**Lakeside Park Section 5, 6, 7
GASB 34 Calculation**

RE: Elliott Creek Drain, Lakeside Park Section 5 Arm

Re: Elliott Creek Drain: Lakeside Park Section 5

**Re: Elliott Creek Drain: Lakeside Park Section 5
 (Revised Final Report)**

STORM PLAN & PROFILES
 LAKESIDE PARK
 SECTION FIVE

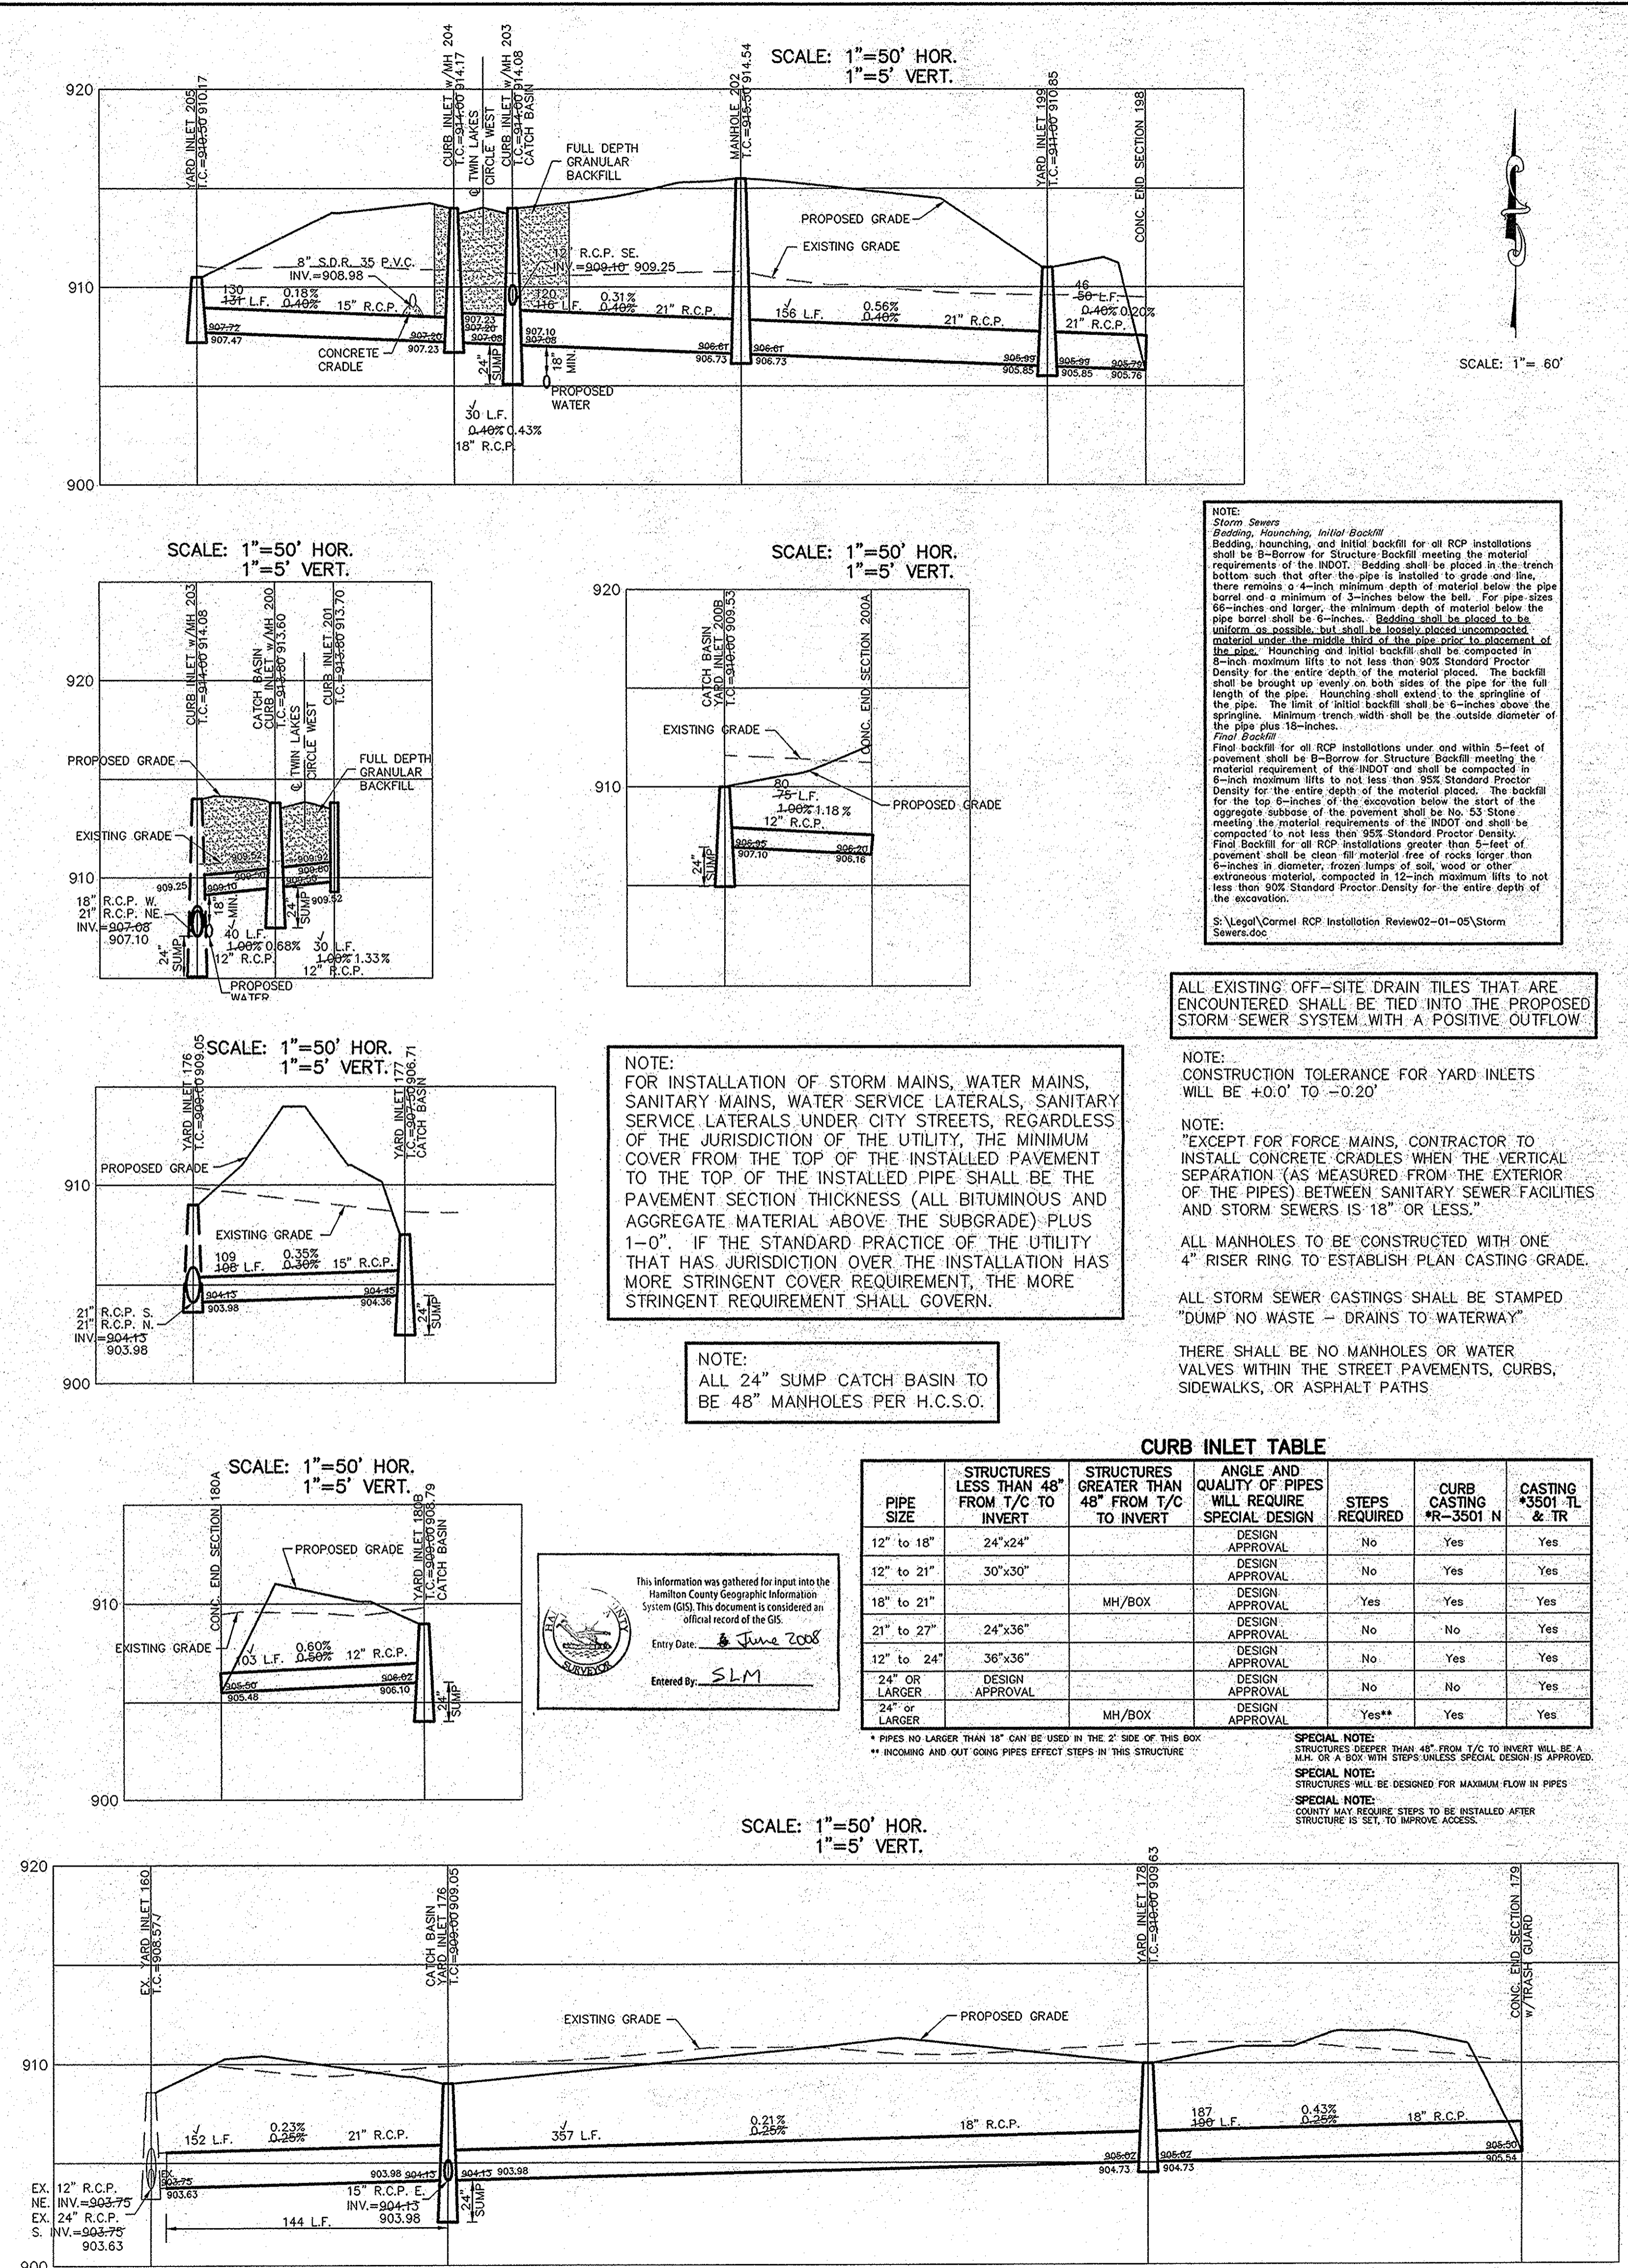
During construction, changes were made to the drain, which will alter the plans submitted with my report for this drain-dated October 17, 2007. The report was approved by the Board at the hearing held November 26, 2007. (See Drainage Board Minutes Book 10, Pages 499-500) The changes are as follows:

Structure:	Length:	Size	Material:	Up Invert:	Dn_Invert	Grade:	Changes:
200B-200A	80	12	RCP	907.1	906.16		-5
179-178	187	18	RCP	905.54	904.73	0.43	-3
178-176	357	18	RCP	904.73	903.98	0.21	
176-160	152	21	RCP	903.98	903.63	0.23	
177-176	109	15	RCP	904.36	903.98		1
205-204	130	15	RCP	907.47	907.23	0.18	-1
204-203	30	18	RCP	907.23	907.1	0.43	
203-202	120	21	RCP	906.73	905.85	0.56	4
202-199	156	21	RCP	906.73	905.85	0.56	
199-198	46	21	RCP	905.85	905.76	0.2	-4
201-200	30	12	RCP	909.92	909.52	1.33	
200-203	40	12	RCP	909.52	909.25	0.68	
180A-180B	68	12	RCP	906.1	905.48	0.23

The length of the drain due to the changes described above is now **5025 feet**. It should be noted that this footage reflects the changes done by the City of Carmel at the 141st St & Towne Roundabout instillation (See my report dated August 26, 2008).
